City of Pacific Grove
Architectural Review Board Report

Subject: Consideration of Architectural Permit and Tree Permit with Development (AP TPD 16-020) to demolish a one-story single-family residence of 1,375 square feet, and to create a two-story single-family residence of 2,753 gross square feet, including the removal of one *Metrosideros tomentosa* tree

Application: Architectural Permit and Tree Permit With Development #16-020

Location: 1269 Surf Ave. Pacific Grove, CA 93950

New Zealand Christmas Tree to be removed

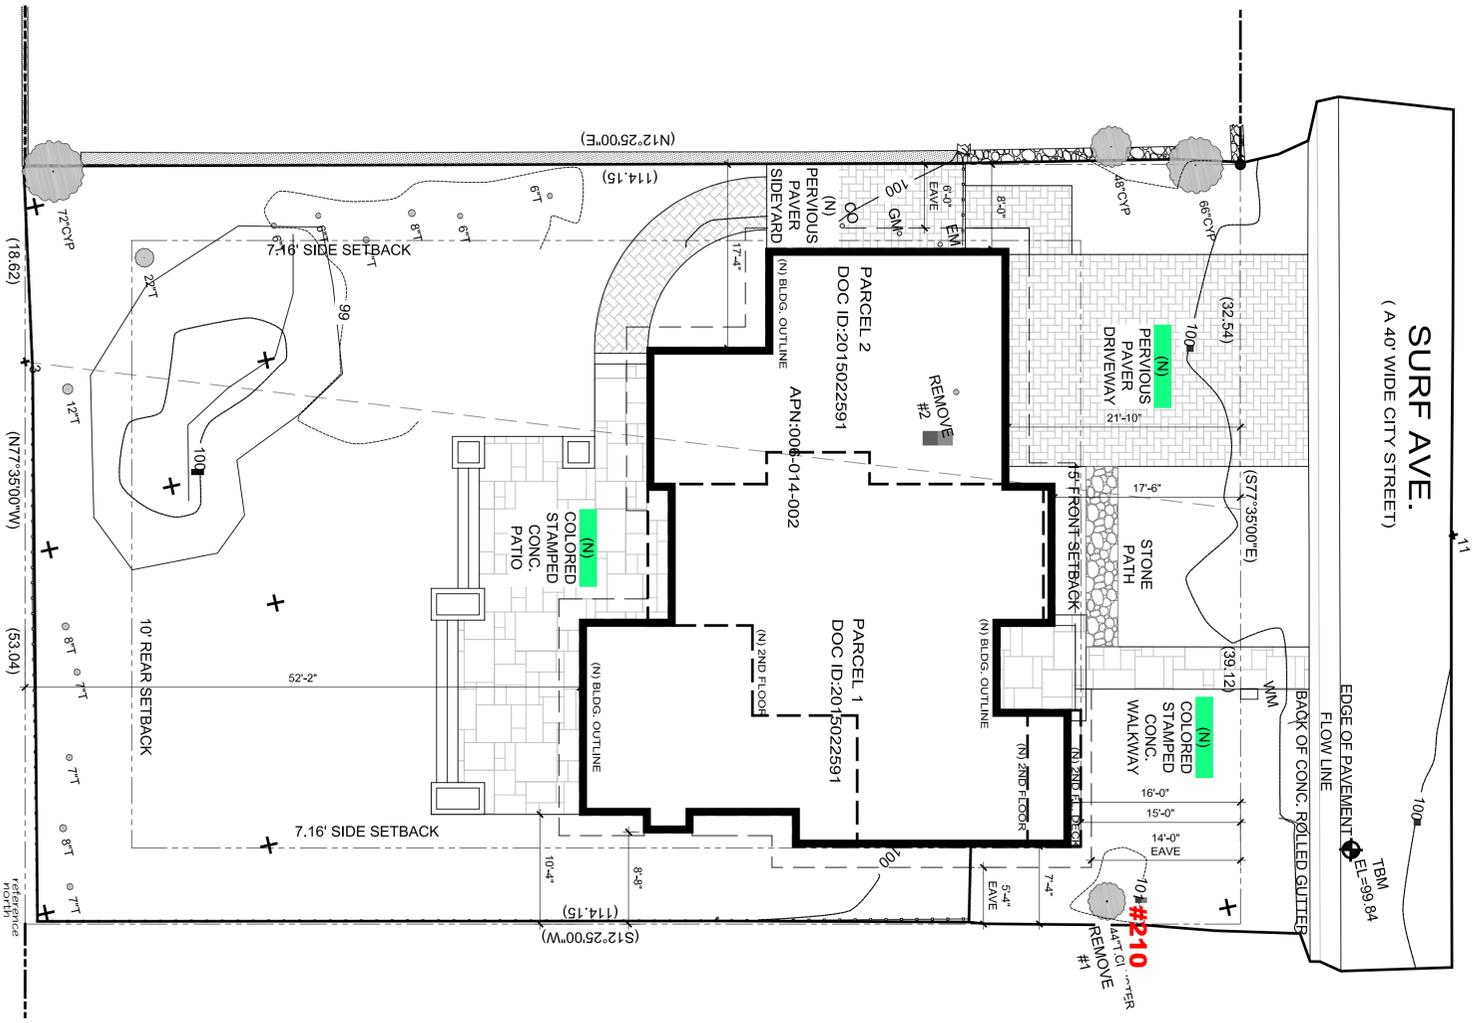
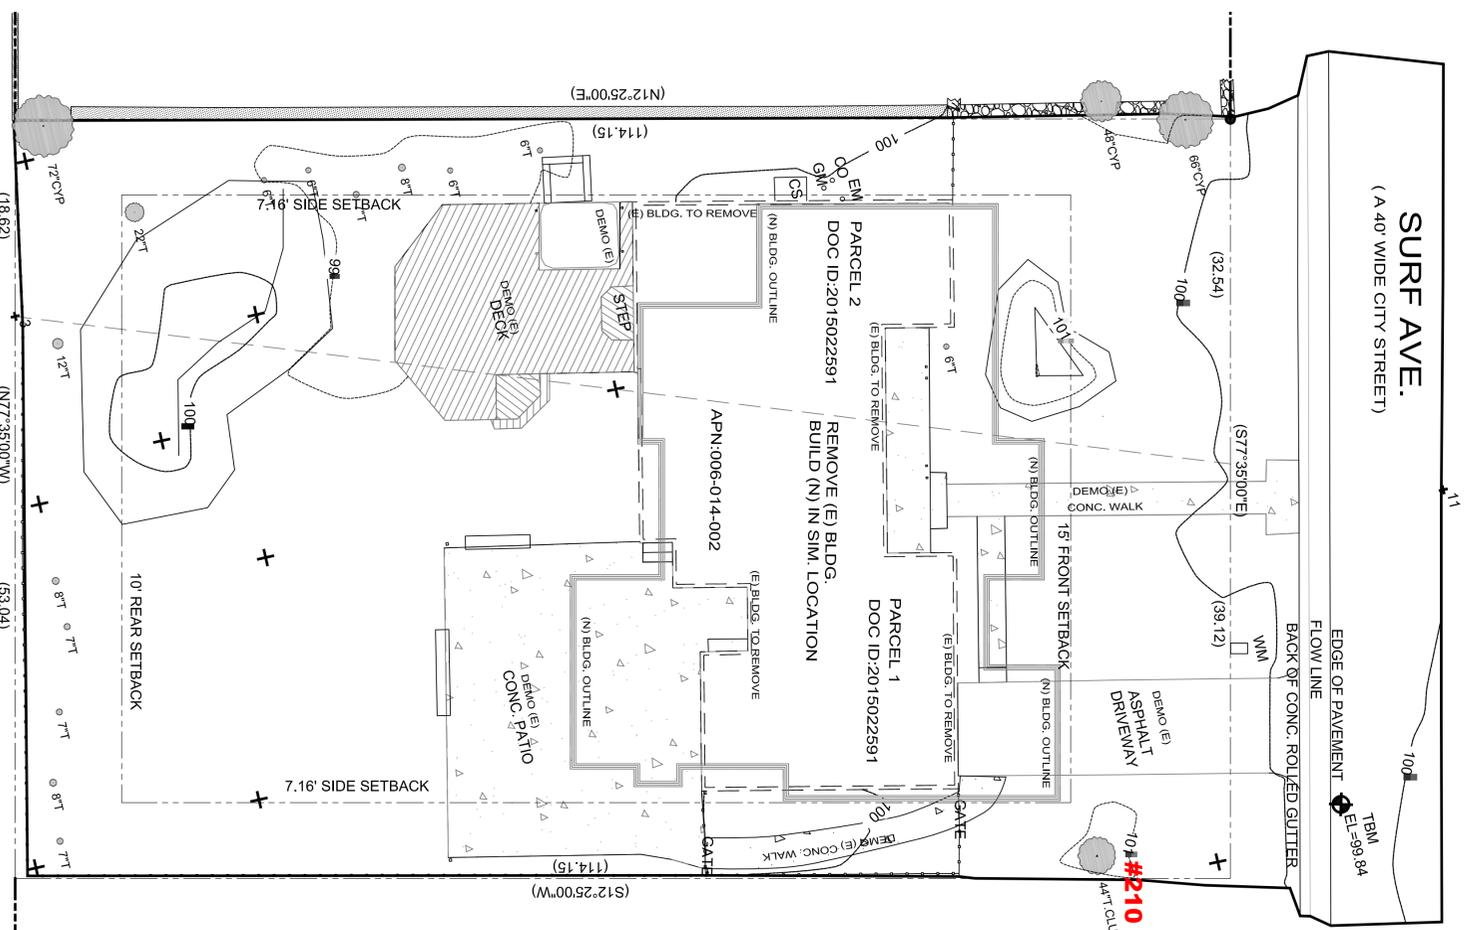
The City's Arborist reviewed the project proposal and has concerns with the applicant's tree report. The City's Arborist has denied the application request to remove the tree. According to the City Arborist, the tree, although not native, is considered mature, established, has a Low Risk rating of 4, and is in the Risk Category of 2. Furthermore, the project will replace the existing driveway with vegetation, and create a new driveway approximately 40 feet away from the tree. Therefore, there will be no impact on the newly proposed driveway. The City's Arborist is allowing one branch of the *Metrosideros Tomentosa* tree to be removed, as well as minimal crown reduction and tree trimming. *(Please see Attachment D.)*

There are several trees of concern. One tree is proposed for removal; a New Zealand Christmas tree (*Metrosideros tomentosa*) composed of multiple stems (18", 11", 8", 6", 6", 5", and 4" diameters). The tree has stems which are weakly attached to a common base or root crown. The relative healthy tree problematic having a very full crown but with weakly attached stems; the root crown is also lifting in the soil and currently creating property damage. The buttressed root crown is lifting adjacent areas; most notable is where the concrete driveway is cracked from large surface root uplift and appears to be headed toward the garage floor. The two mature Monterey cypresses (*Cupressus macrocarpa*) are also located fairly close to the new proposed driveway area. These are well established trees appearing to be in fair or better health. Roots are observed lifting the rolled curb and gutter portion of the street where the new driveway is proposed. The trees are to be retained but may need root pruning to correct the lifted rolled curb and gutter. It appears that some root pruning or shaving may also be necessary to install the new driveway.

The New Zealand Christmas tree is a non-native tree which was planted as part of the landscape. It appears from its multiple stem growth, the tree may have been originally a shrub that over the years has escaped containment by pruning (most New Zealand Christmas trees if intended as a tree are usually planted as standard single stemmed tree, not a shrub). The new structure and driveway requires substantial root removal of the New Zealand Christmas tree, therefore its removal and replacement is recommended as its removal will not significantly affect air movement or erosion. The Cypresses are much larger mature trees appearing well rooted in the soil. In this case necessary root pruning does not appear it will significantly affect the tree. As a pre-caution root pruning should be monitored to insure that only those roots necessary are to be pruned correctly.

The request for removal has been denied based on the following reasons:

- A. The tree in question does not meet the criteria of high-risk tree per the City’s tree ordinance, per Pacific Grove Municipal Code Section 12.40.010.
- B. The tree in question is considered to be in the Low Risk rating (4) and Risk Category of (2). A risk category of (2) is defined as insignificant-very minor issues. Please see the table “Overall Risk Rating and Action Thresholds” below, which is defined in the City of Pacific Grove’s Urban Forestry Standards, Section 2.2.1, Levels of Assessment:

Furthermore, plans indicate that the existing driveway is to be removed and replaced with vegetation and landscaping. Because the driveway is to be removed and replaced with vegetation, it therefore will not damage the root system of the tree. The damage to the driveway likely caused by roots of the subject tree will be mitigated by removal of the hardscape and replaced with natural landscape, in return benefiting the tree.
